STATE OF MAINE
DEPARTMENT OF TRANSPORTATION
16 STATE HOUSE STATION
AUGUSTA, MAINE
04333-0016

March 1, 2011
Subject: **Sidney & Augusta**
Federal Project No: IM-1679(000)E
State PIN: 016790.00
Amendment No. 1

SGM06a

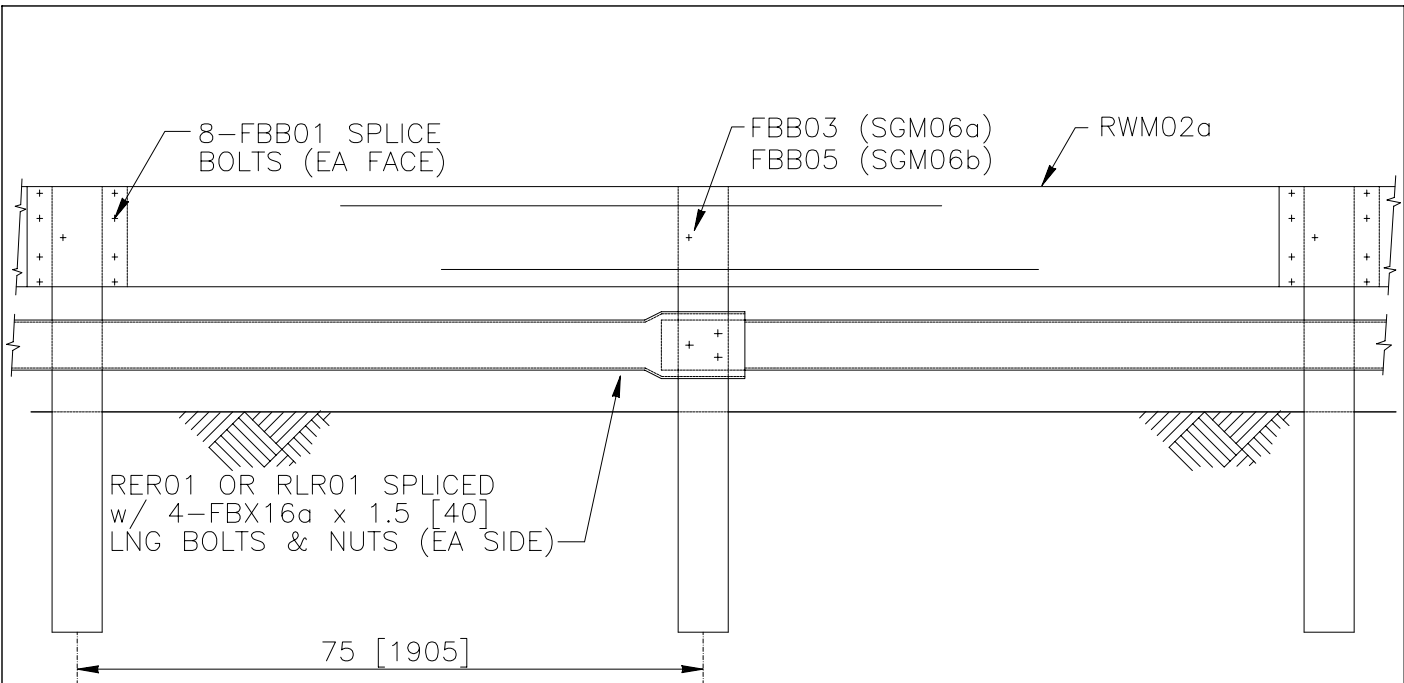
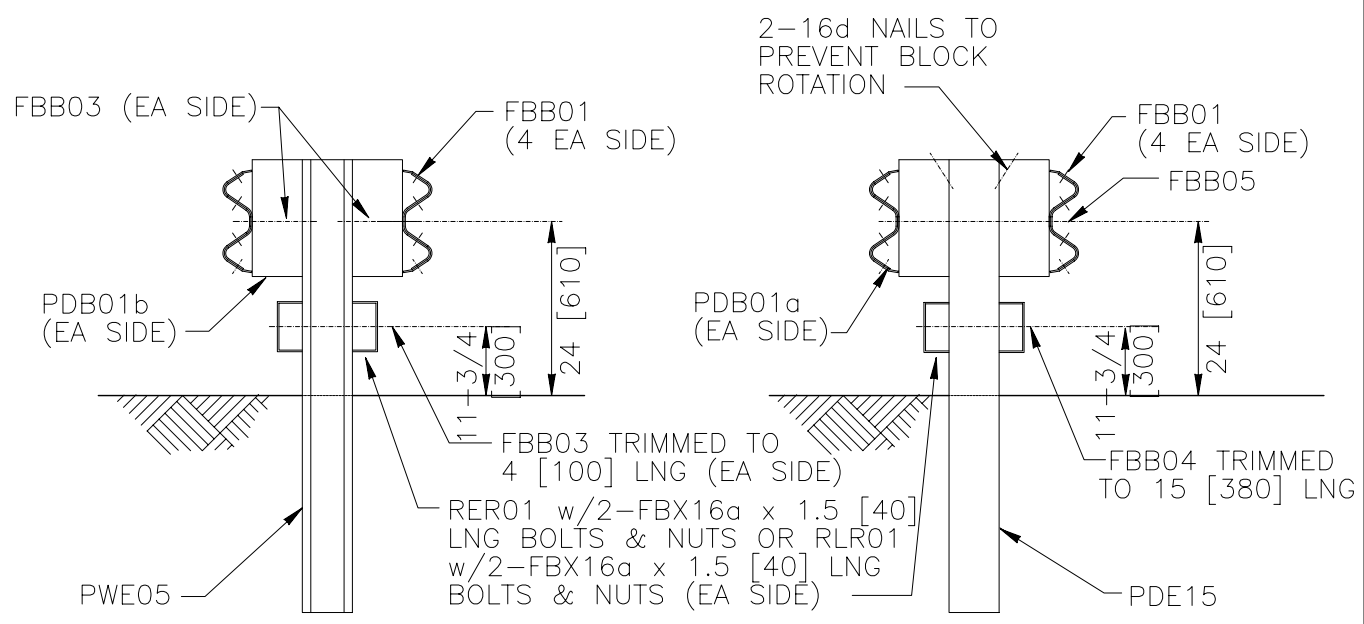
Question: What is the spec. for rub-rail, item 606.56, there are different options?

Response: The median guardrail shall be provided and installed in accordance with the attached AASHTO detail SGM06a-b, the Special Provisions and the following:

Use the composite block option

Use the C6x8.2 channel option

Use 8' posts as noted on the Special Provision drawing.
